# DPF Harness Routing

M-373-001

(July 2009)

All MRU and LEU Models

## MRU Models

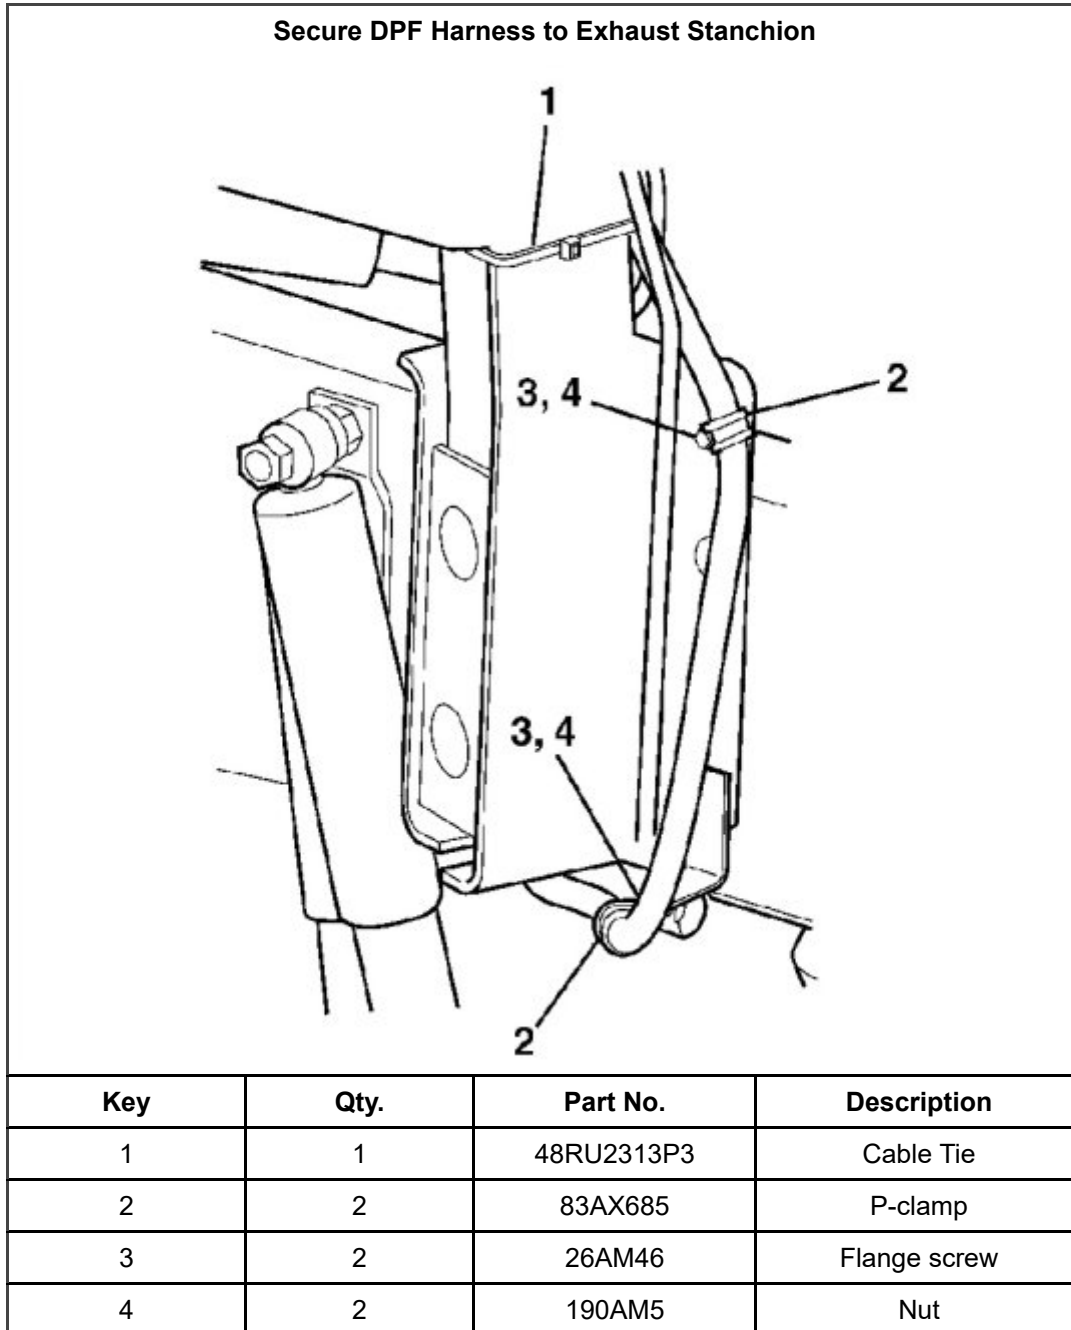
Should replacement of a DPF harness be necessary on an MRU or LEU model chassis, it is essential that the DPF harness-to-chassis harness connector be repositioned inside of the frame rail, out of the wheel splash area. Replacement DPF harnesses available through the MACK Parts System are longer than the existing harness to facilitate relocating the connector.

1. After removing the existing DPF harness, relocate the chassis harness DPF connector so that the connector is located inside the frame rail.

2. Install the replacement DPF harness (part No. 21285474 for the non-catalyzed DPF [MRU with MP7 engine] or 21311747 for the catalyzed DPF [MRU with MP8 engine]).
3. Route the harness down the exhaust stanchion, and secure the harness to the stanchion mount with two P-clamps (part No. 83AX685), flange screws (part No. 26AM46) and nuts (part No. 190AM5) as shown in the illustration below. The lower P-clamp is secured to the same L-bracket where the hoses for the cab tilt pump are secured. Use cable tie (part No. 48RU2313P3 to secure the harness to the stanchion.

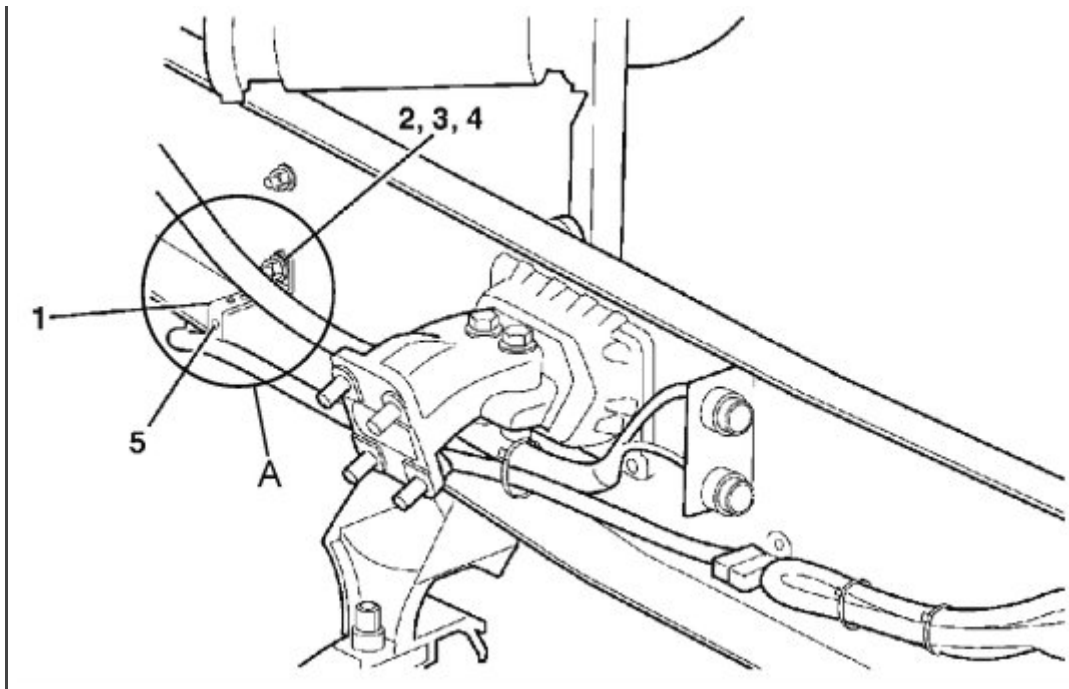
4. Continue routing the DPF harness toward the rear of the chassis, under the transmission mount. Connect the DPF harness connectors to the chassis harness connectors.

*Note: Connect DPF harness to the electric fuel pump/ shut off valve assembly (Non Catalyzed DPF models).*

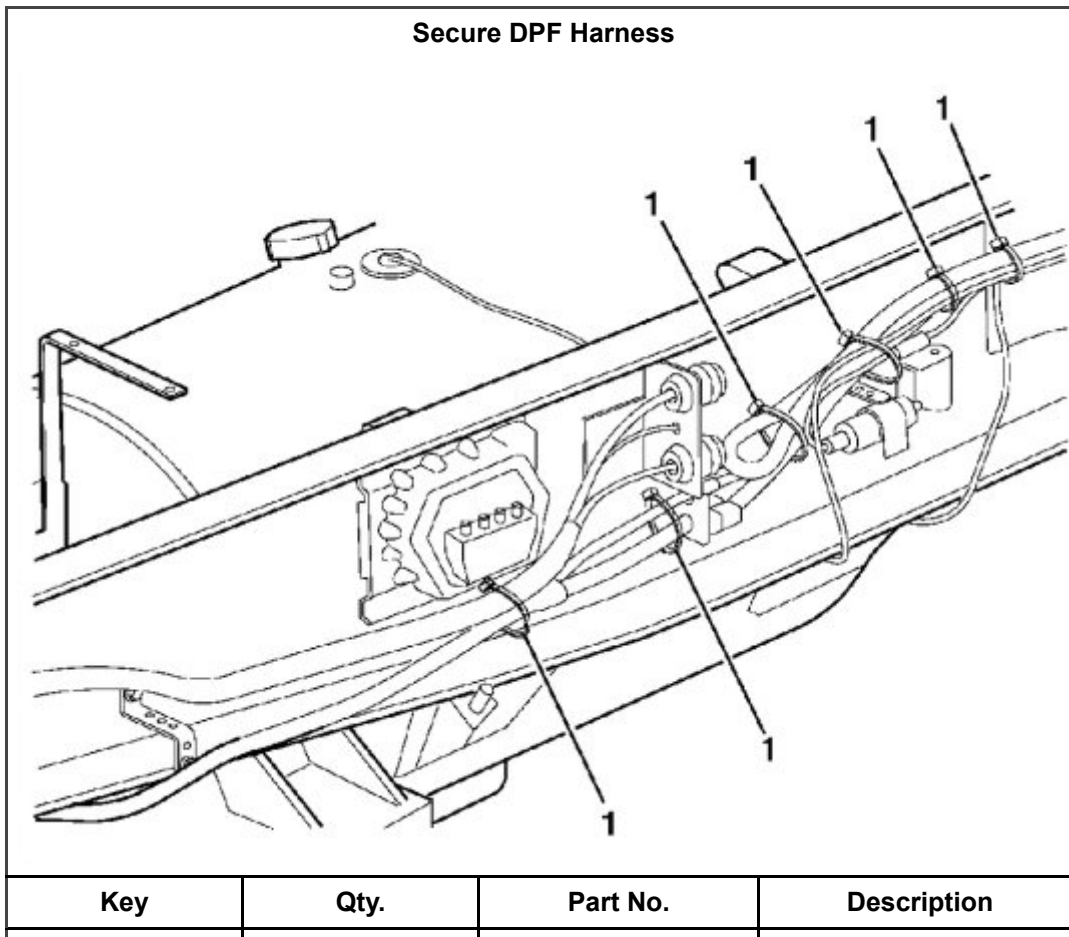
5. Mounting hardware may be present at location (A) for mounting suspension brackets. If no mounting hardware is present, install mounting hardware using bolt (part No. 1AX46), flat washer (part No. 35AX1249) and locknut (part No. 21AX784). Install an L-bracket (part No. 73RU4269M) on the frame rail, just forward of the transmission mount as shown in the illustration below. Use cable tie (part No. 46RU3115M) to secure the DPF harness to the L-bracket.

6. Use cable ties (part No. 48RU2313) to secure the DPF harness to the body builder harness.
7. Loop any excess chassis harness length back on itself, and secure with cable ties (part No. 48RU2313). Also, secure the harness connector to the L-bracket with cable tie (part No. 48RU2313).

**Secure DPF Harness to Exhaust Stanchion**

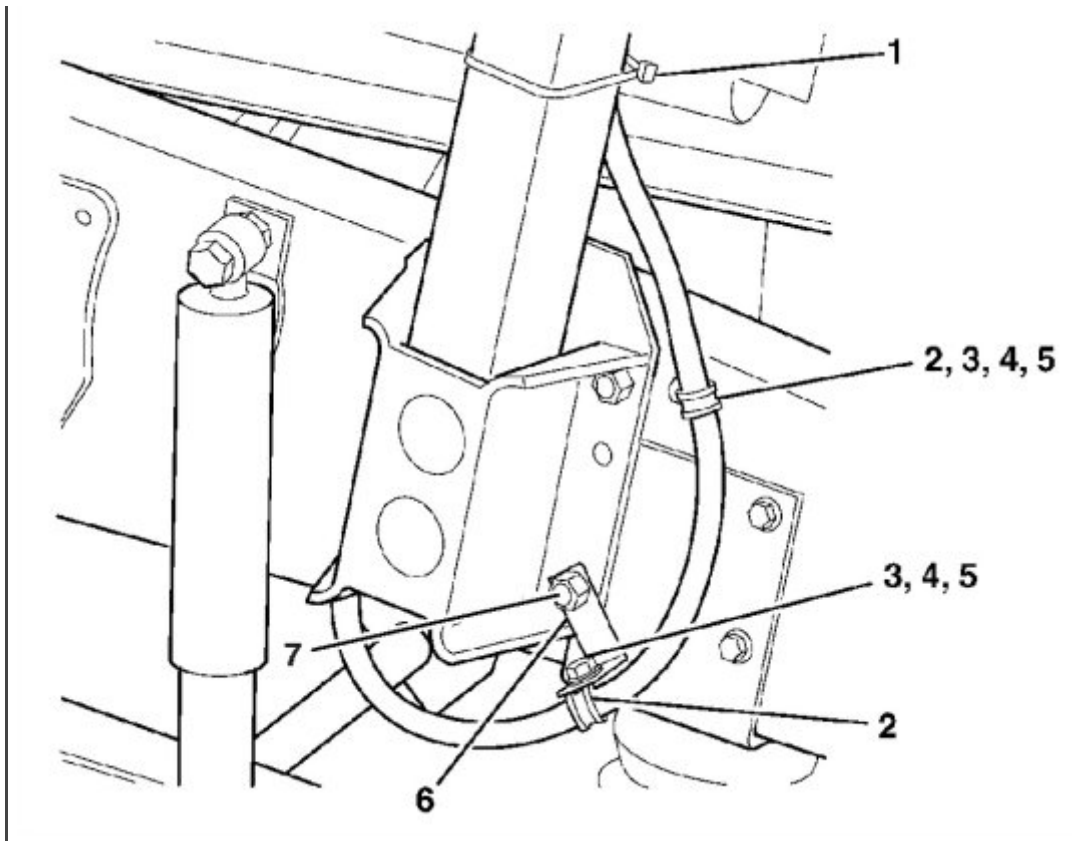
1. After removing the existing DPF harness, relocate the chassis harness DPF connector so that the connector is located inside the frame rail.
2. Install the replacement DPF harness (part No. 21285474).
3. Remove the nut from the lower front exhaust stanchion mounting bracket, and then Install an Lbracket (part No. 72RU439M2) on the bolt and secure with the existing nut. Route the harness down the exhaust stanchion. Secure the harness to the frame rail and the L-bracket with P-clamps (part No. 83AX685). Use bolts (part No. 1AX32), lock washers (part No. 36AX1) and nuts (part No. 20AX1) to secure the P-clamps to the frame rail and L-bracket. Use cable Tie (part No. 48RU2313P3) to secure the harness to the stanchion.

*Note: Be sure to provide enough slack in the harness where it is routed under the frame rail to prevent it from rubbing against the lower frame flange.*

**Install L-Bracket and Secure DPF Harness with Cable Ties**

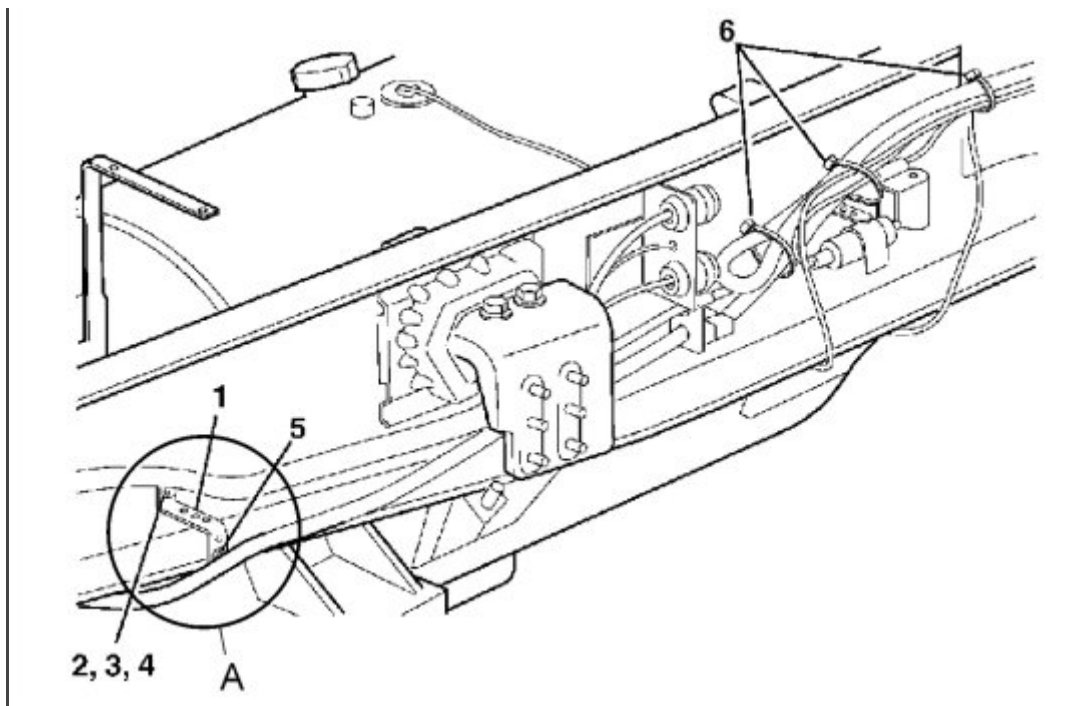
4. Continue routing the DPF harness toward the rear of the chassis, under the transmission mount, and connect to the chassis harness connector.
5. Mounting hardware may be present at location (A) for mounting suspension brackets. If no mounting hardware is present, install mounting hardware using using bolt (part No. 1AX46), flat washer (part No. 35AX1249) and locknut (part No. 21AX784), Install an L-bracket (part No. 73RU4269M) on the frame rail, just forward of the transmission mount as shown in the illustration below. Use cable Tie (part No. 48RU3115M) to secure the DPF harness to the L-bracket.
6. Use cable ties (part No. 48RU2313) to secure the DPF harness to the body builder harness.
7. Loop any excess chassis harness length back on itself, and secure with cable ties (part No. 48RU2313). Also, secure the harness connector to the L-bracket with cable tie (part No. 48RU2313).
